Belleterre Subdivision Sketch Plan

PART 1: PROJECT SUMMARY

Applicant: Bowman Development

Proposed Land Use: 18 Single Family Residential lots.

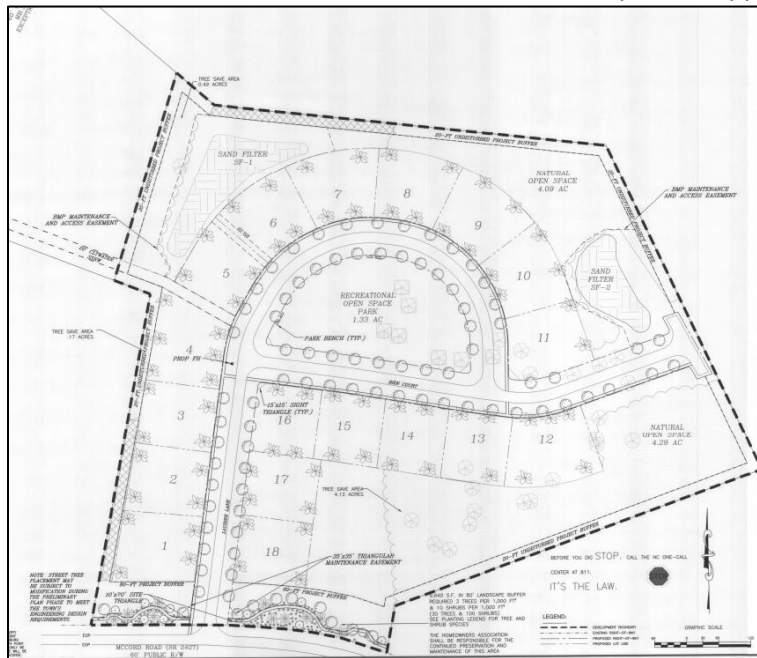
4. The proposed project is not located within a regulated watershed. 42.89% impervious is being proposed on-site; therefore the applicant has to meet the Low-Impact Development (LID) requirements by installing best management practices (BMPs).

5. The applicant is required to save 50% of the existing tree canopy and 50% of the existing specimen trees. 51% of the existing tree canopy and 76% of the existing specimen trees onsite are proposed to be saved.

6. Street standards, connectivity, setbacks and lot sizes are compliant with the zoning and subdivision ordinance.
7. Buffer requirements are being met per Article 7.5. A 20' undisturbed residential buffer is being maintained and along McCord Road an 80' planted buffer is required. The applicant is installing a meandering sidewalk within the 80' buffer along with appropriate landscape material to meet the requirements of the ordinance.

8. The cross-section of McCord Road will accommodate for a bike lane on the north side.
9. The updated plan submitted on June 14, 2017 was reviewed and is ready for an approval.
